V2500 Propulsion System — Nacelle

SERVICE BULLETIN

Subject: Transmittal of Revision 4 to Service Bulletin Number V2500-NAC-78-0155

NACELLE — EXHAUST — RUB BLOCKS, COMMON NOZZLE ASSEMBLY — MODIFICATION OF

CNA Rub Block Installation
Figure 1 (Sheet 2)

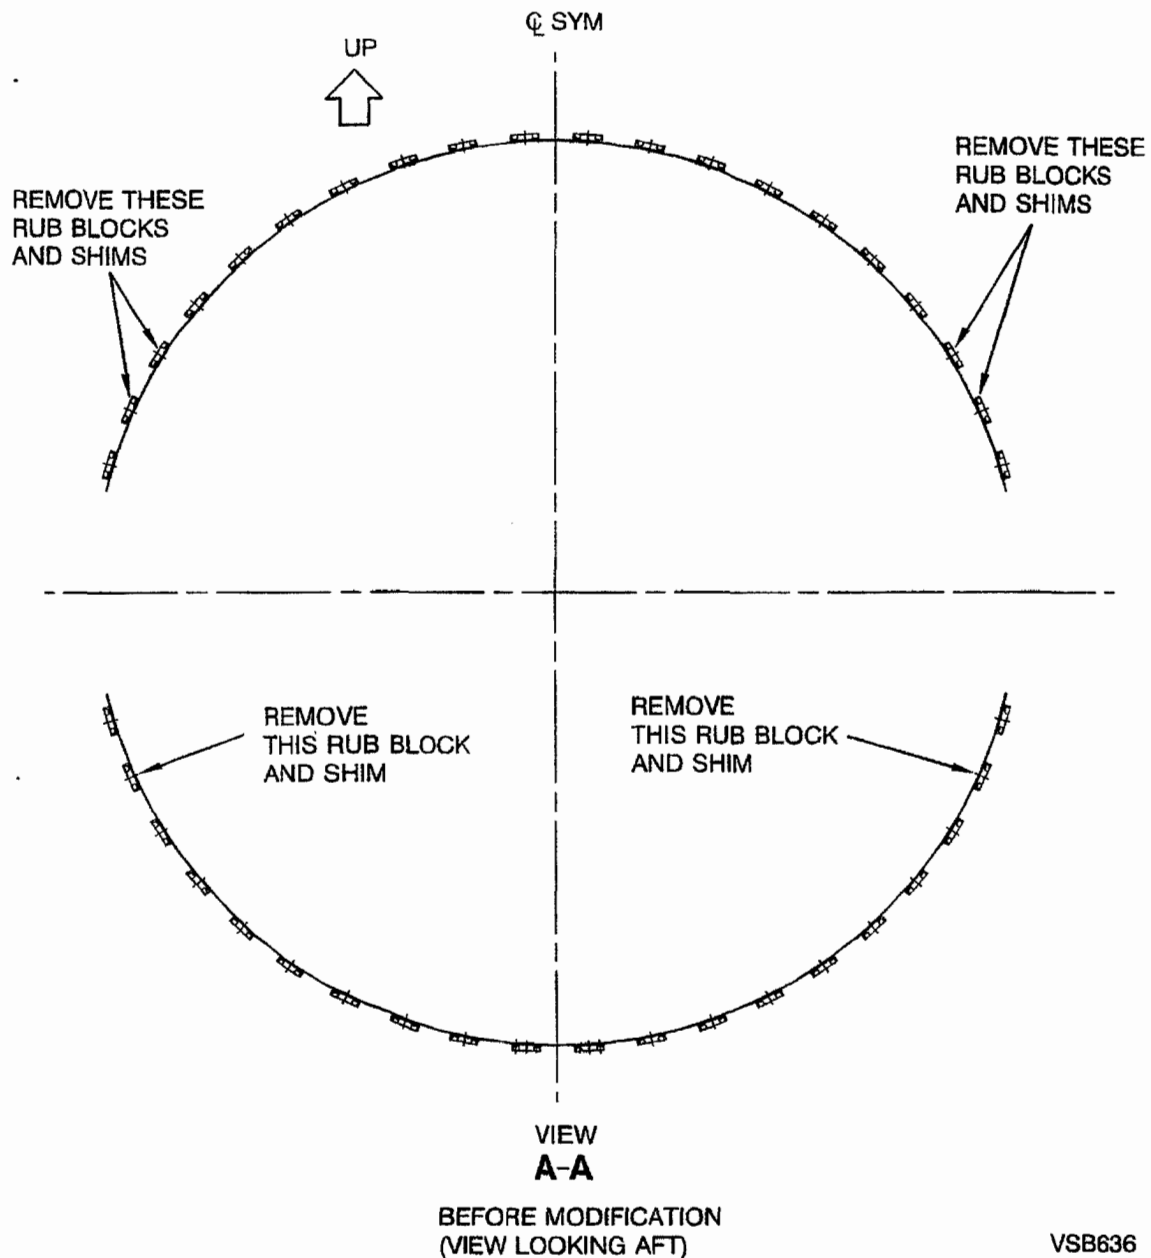
- (1) Remove the fasteners, three rub blocks, and associated shims from each side of the CNA. Refer to Figure 1 (sheet 2).

CNA Rub Block Installation Modification
Figure 1 (Sheet 3)

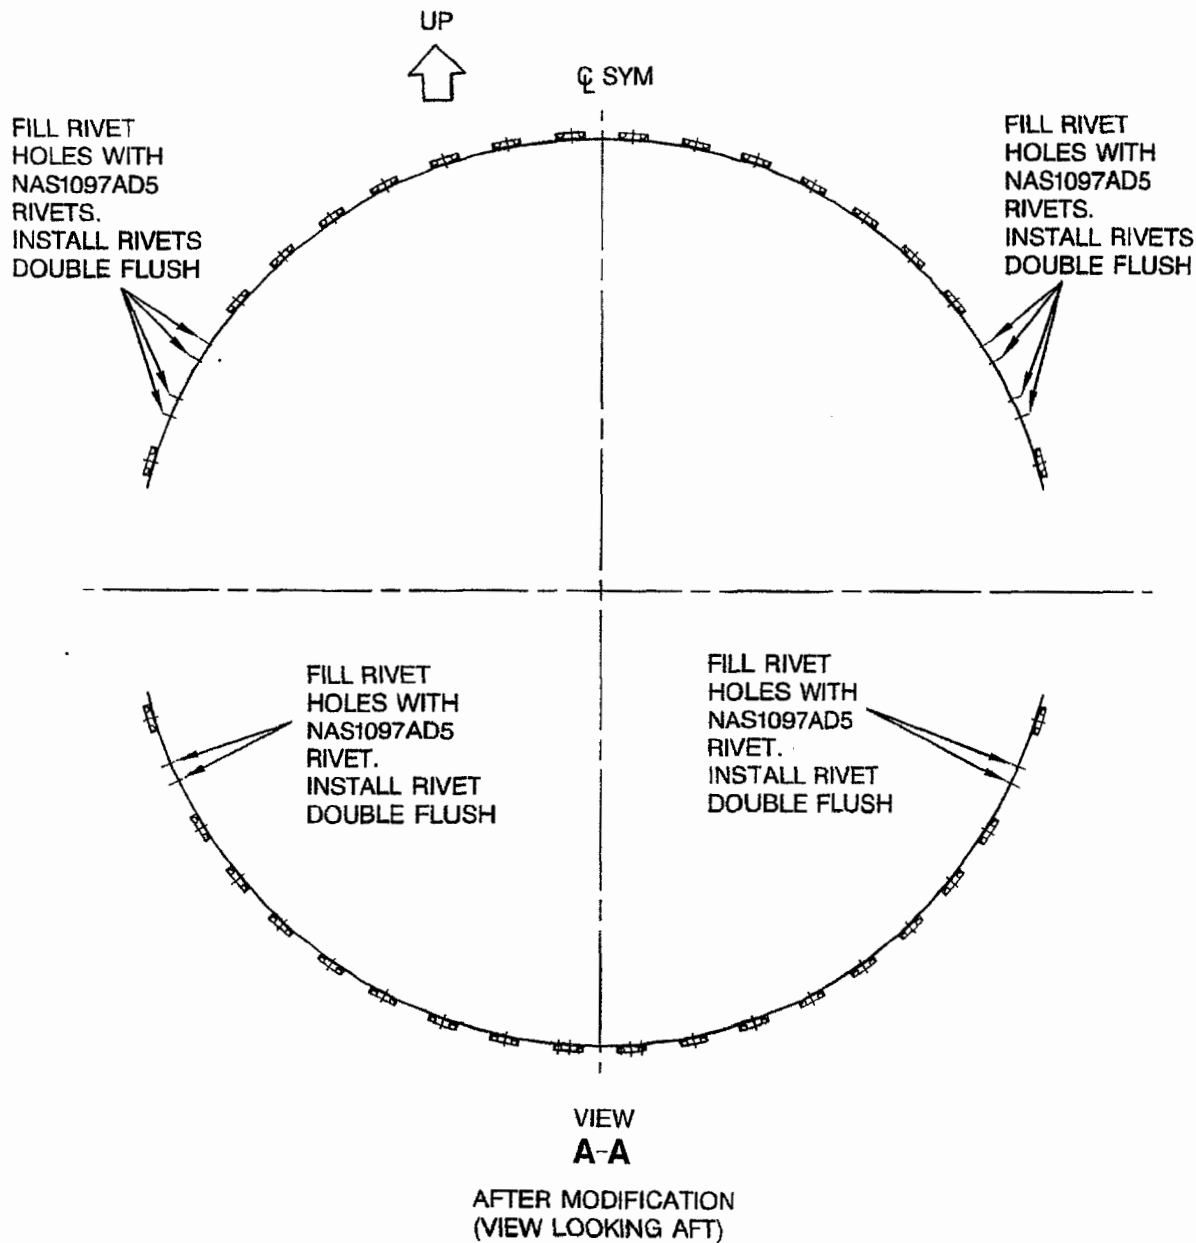
- (4) Mix the catalyst (CoMat 07-139), epoxy primer (CoMat 07-140), and thinner (CoMat 07-144). Refer to the manufacturer's instructions.
- (5) Apply the primer to the treated aluminum areas. Refer to the manufacturer's instructions.
- (6) Cure the primer. Refer to the manufacturer's instructions.
- (7) Fill the empty rub block fastener holes with the NAS1097AD5 rivets. Wet install the rivets with primer mix. Refer to Figure 1 (sheet 3).

NOTE: Because of limited access, you will not be able to fill some of the holes with rivets. Fill these holes with adhesive (CoMat 08-021).
